SUBJECT: SEP SAFETY TOPIC III-6, SEISMIC DESIGN CONSIDERATION AND
III-11, COMPONENT INTEGRITY - DRESDEN NUCLEAR POWER STATION
UNIT NO. 2

SEP SAFETY TOPIC EVALUATION

DRESDEN NUCLEAR POWER PLANT UNIT 2

TOPICS: III-6, Seismic Design Consideration
III-11, Component Integrity

FIGURE 1

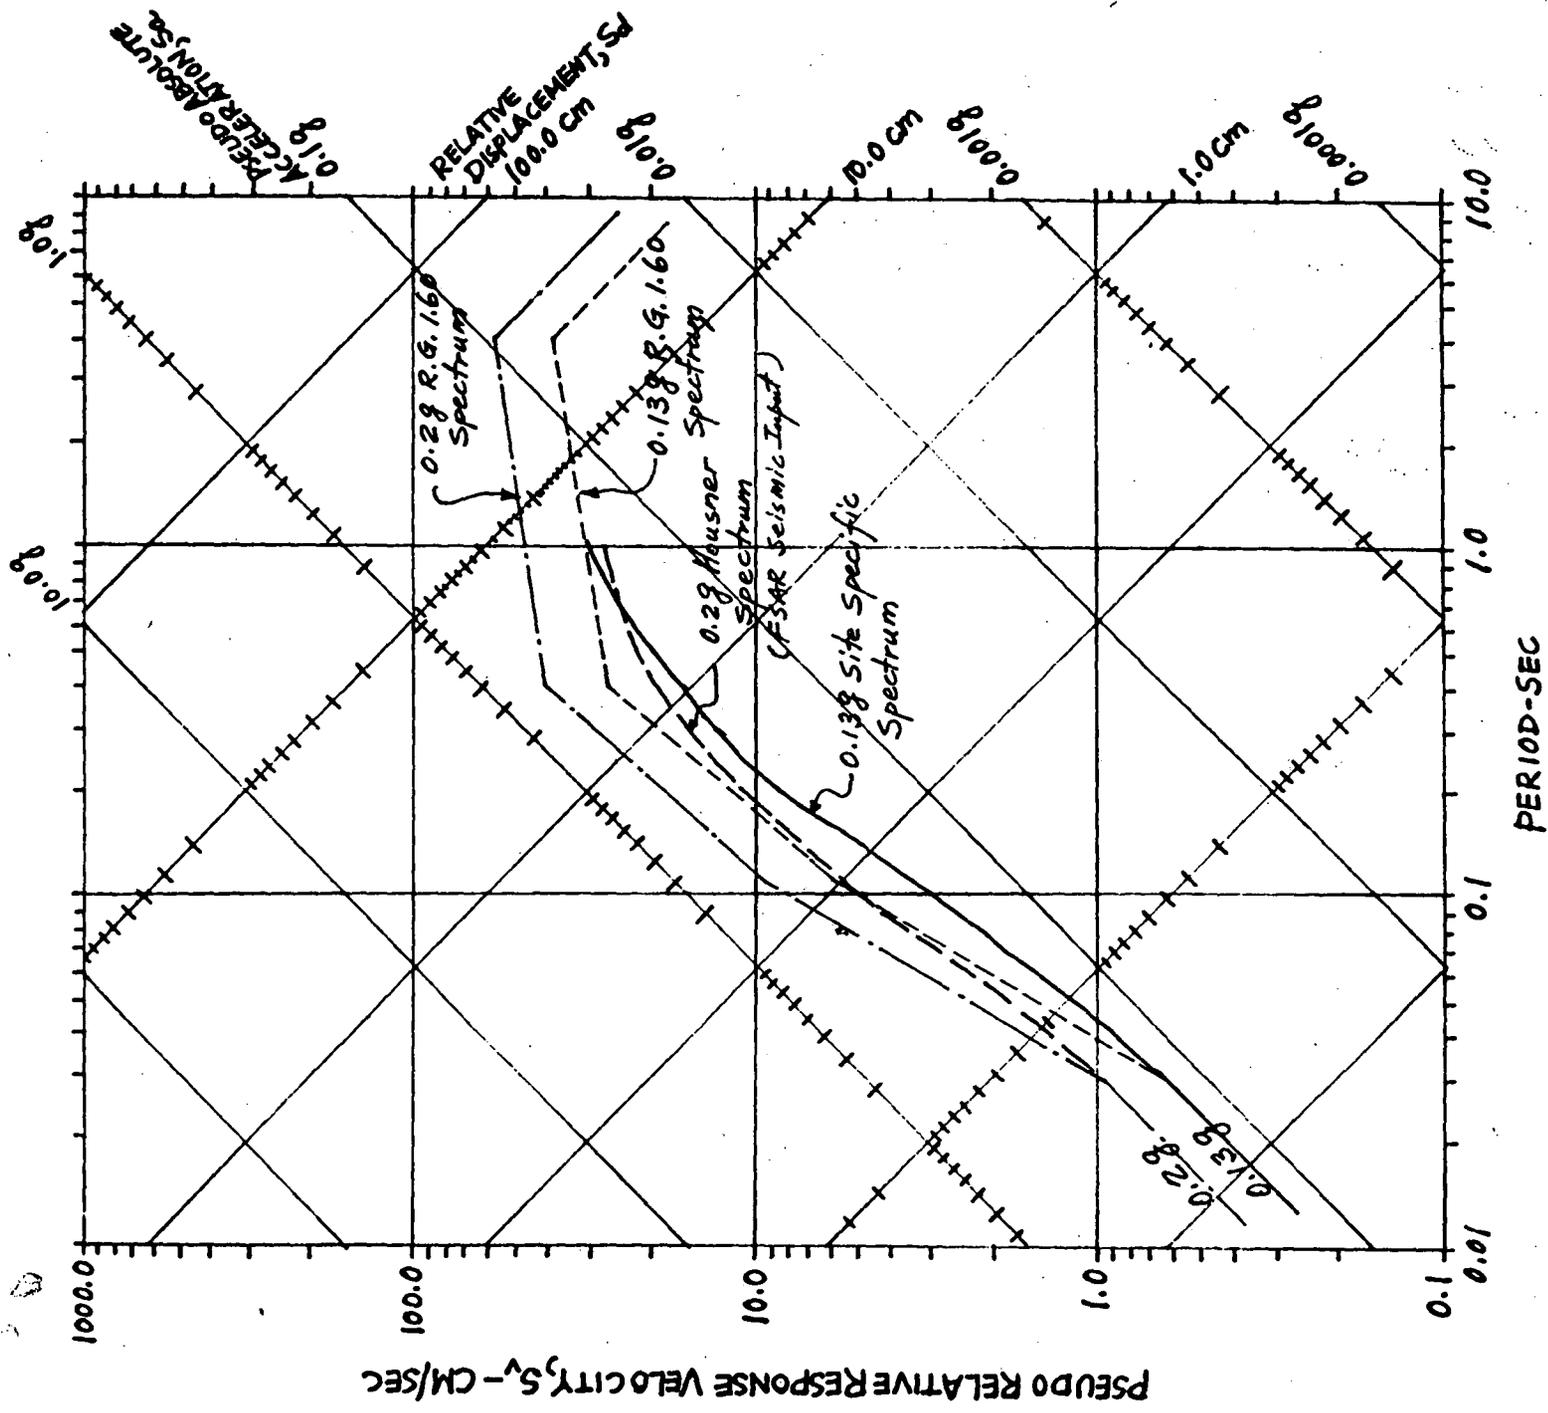
Dresden 2 facility, namely the Regulatory Guide 1.60 spectrum scaled to 0.2g peak ground acceleration, envelopes the Dresden 2 site specific ground response spectrum as shown in Figure 1; therefore, the results for these four safety topic evaluation will not affect the review of seismic design considerations and component integrity.

The licensee has proposed to complete all work associated with the IE Bulletin 79-14 by December 31, 1983. As shown in Figure 1, the FSAR seismic input (Housner ground response spectrum anchored at 0.2g) is more conservative than the site specific spectrum which was developed by NRC for seismic reevaluation of the Dresden site. Based upon the low probability of an earthquake with ground motion which exceeds the NRC's site specific spectrum, the conservatism of the FSAR seismic input and margins which exist in FSAR design criteria for piping systems it is appropriate to resolve the "adequacy" or conservatism of the original design of piping supports as part of the IE Bulletin 79-14 effort.

Furthermore, since the ground response spectrum (0.13 R.G. 1.60 spectrum) used for Dresden 2 reevaluation and the 0.2g Housner ground response spectrum used for the original seismic design envelope the Dresden 2 site specific ground response spectrum, additional safety margins in the structures, systems and components do exist for resisting SSE seismic loadings.
